From: Carolyn Milnes <CMilnes@devonport.tas.gov.au>
Sent: Tuesday, 30 January 2024 9:33 AM
To: TPC Enquiry; Townsend, Janelle
Subject: Devonport - draft amendment AM2022.01 and permit PA2022.0024
- CAS Comments - stormwater management - 133 Middle Road,
Miandetta

From: Cymbaline, Cym <Cym.Cymbaline@nre.tas.gov.au>
Sent: Tuesday, January 30, 2024 8:28 AM
To: Carolyn Milnes <CMilnes@devonport.tas.gov.au>
Cc: Kuechler, Antje <Antje.Kuechler@nre.tas.gov.au>
Subject: CAS Comments - stormwater management - 133 Middle Road, Miandetta

DEV-S5.7.1 Stormwater

Mapping below shows the Environmental Management, General Residential and Open Space Zones.

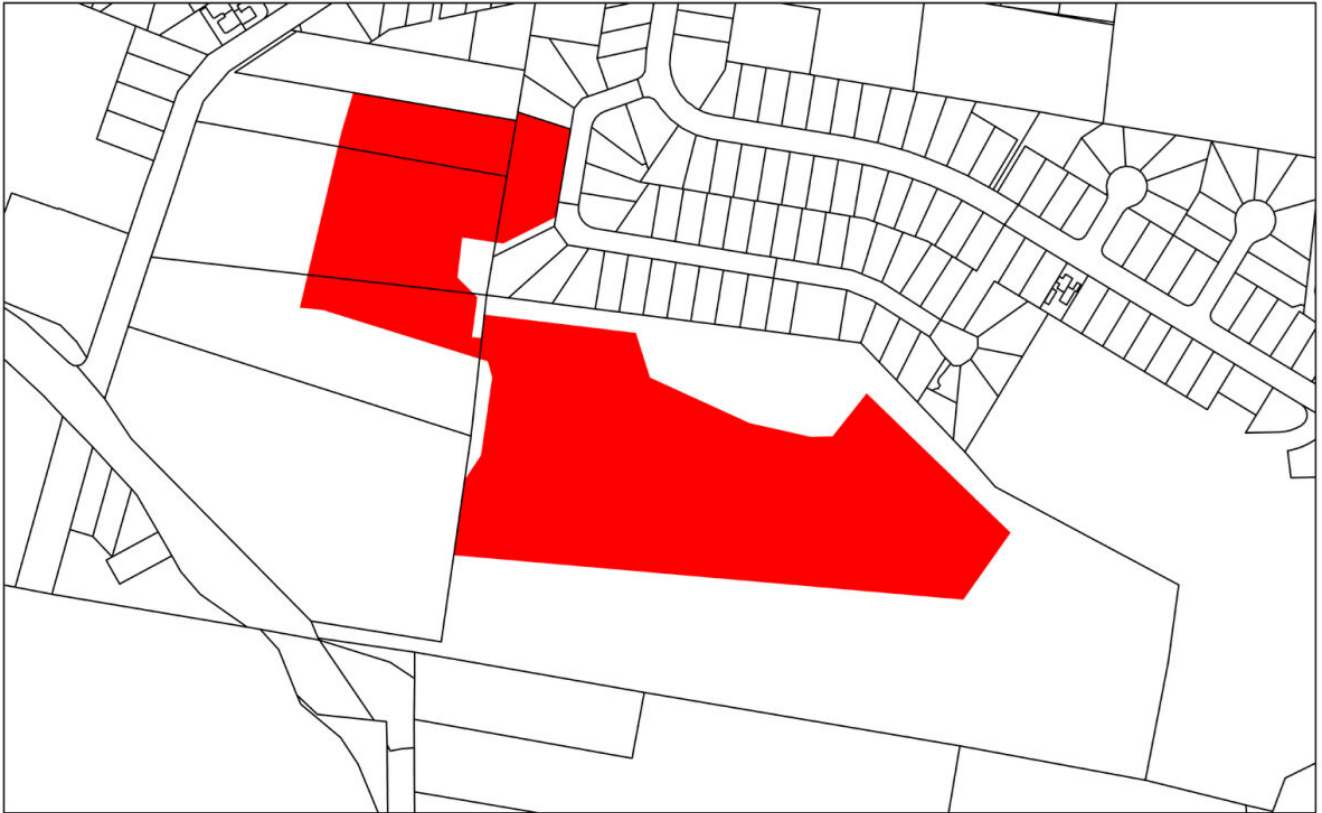
At the request of the Tasmanian Planning Commission the proposal has since changed to include an area of Environmental Management Zone which will encompass the above habitat (see maps below). Areas of Open Space Zone and General Residential Zones are also proposed.

Adjacent to the Environmental Management Zone will be the General Residential Zone which will likely be subdivided into residential lots although the configuration is currently unknown. There is also potential for large multiple dwelling development or other residential development such as nursing homes. I'm seeking advice regarding the best way to ensure that the stormwater flows from the General Residential land make its way to the Environmental Management Zone.

We have proposed a standard that requires as least 40% of each future residential lot is impervious to allow for stormwater absorption and therefore maintain flows to the Environmental Management Zone (see below). Another suggestion is to allow for one single dwelling without other constraints, however I feel this would allow people to potentially cover a much larger portion of the site with hardstand areas, preventing any significant absorption. I am wondering if you think the standard below is appropriate and/or if an area greater than 40% should remain free from impervious surfaces to allow for greater absorption? If clause A1 could not be met then P1 would need to be satisfied which includes referral to an agency such as NRE.

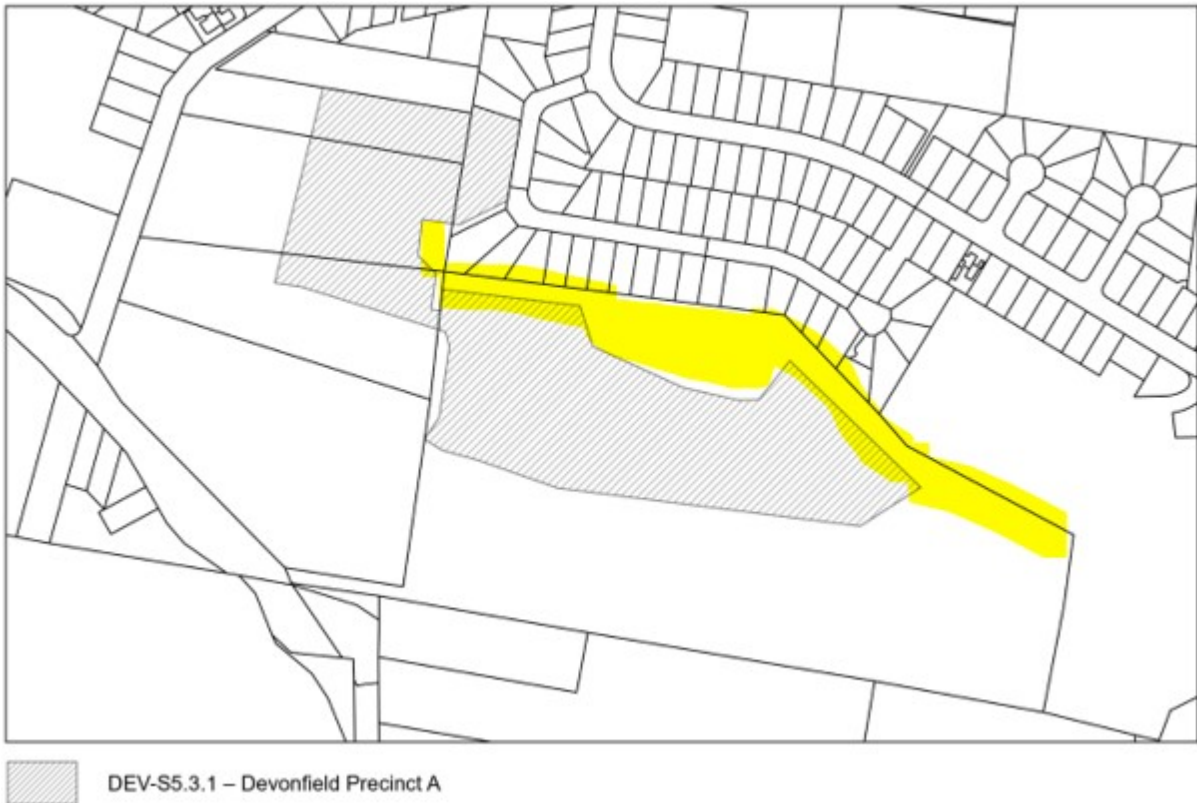
The intention of the Acceptable Solution is to maintain stormwater absorption and therefore ensure as much water as possible makes its way into the habitat areas (highlighted in yellow below). The standard would apply to the hatched area which falls towards the habitat.

My query is, is 40% of each residential lot sufficient to assist with this, and if not, what do you think would be acceptable? It is intended that the land be subdivided into residential lots of 450m² or larger, generally approx. 600m².
